Clash Gour Airspace Change Proposal

ACP-2021-046

Stage 2 Stakeholder Engagement Document

Date: 28th September 2022
Revision: Issue 3
Ref: 71609 020

Figure 1 - Proposed TMZ on LOS Radar Display

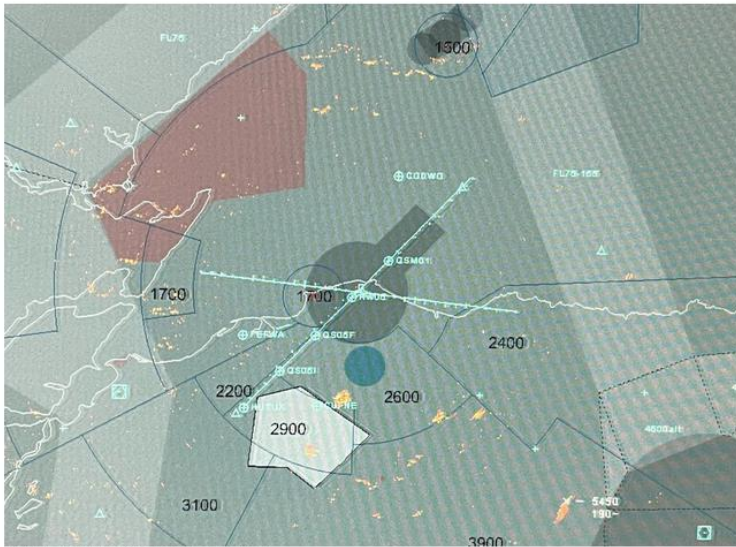
Figure 1 depicts the Lossiemouth AoR with one of the proposed RAG blanked/TMZ area to the south plotted (note this is rough plotting, no guarantee of accuracy). The extended centrelines and RNP procedure map overlays are visible, as well as the Easterton Gliding area (blue circle south of the MATZ). Existing Wind Turbine developments already create a challenge when operating IFR to the south of LOS (clutter visible) for approaches to RWY05, with 2x developments already in situ in the vicinity of the proposed Clash Gour. One of the existing areas of clutter would be covered by the proposed TMZ however the other would not as it is just on the NE edge between TMZ and Easterton.

The presence of the overland TMZ and associated blanking potentially in such close proximity to (and potentially overlapping) existing published IFR arrival/departure procedures may be unacceptable to MOD and they will therefore be seeking further guidance about what is permissible under current regulations and policy. However, if it were to be deemed acceptable, the dimensions of the area must be simple in shape and contain a buffer (size would need to be safety assessed to agree).

Any blanked area and associated TMZ would need to be checked against WAM coverage to ensure there are no gaps or areas of poor coverage that would render aircraft invisible to the controller. As WAM is not yet in service, this is difficult to verify; however, when there is greater clarity on the option(s) to be proposed at stage 3 of the ACP then a request can be made to the relevant authority. An assessment on the performance of the STAR NG radar would also need to be made, to identify the likely impact of the wind turbine on the sensor and what is required to mitigate it, whilst remaining within the bounds of its Release to Service and not undermining the Terminal ATC Operating Safety Case. In the event of a loss of WAM (planned or unplanned maintenance, random failures etc.) the blanking would mean any aircraft operating in the TMZ would not be shown and therefore an ATC Service could not be applied. Operating IFR to runway 05 when Primary (STAR NG) only, is a safety concern to Lossiemouth.

All IFR approaches to RWY05 will be impacted (PAR, TACAN, SRA) and the blanked area would limit Surveillance Radar Approaches to a northerly feed-in, which would limit flexibility and reduce the effectiveness of the service being provided. The TMZ location would funnel non-cooperative traffic to the north, which would put it into conflict with traffic on IFR approaches to RWY05, as well as IFR departures from RWY23, whereas without the TMZ they can freely route to the south of the approach/departure lane. It will also impact RNP procedures (not yet published but in progress), the TACAN Hold for RWY05 and likely to impact ATS provision for departures on the MID23 South. It should be noted that any impact to Lossiemouth procedures may have a knock-on impact to Inverness ATC procedures.
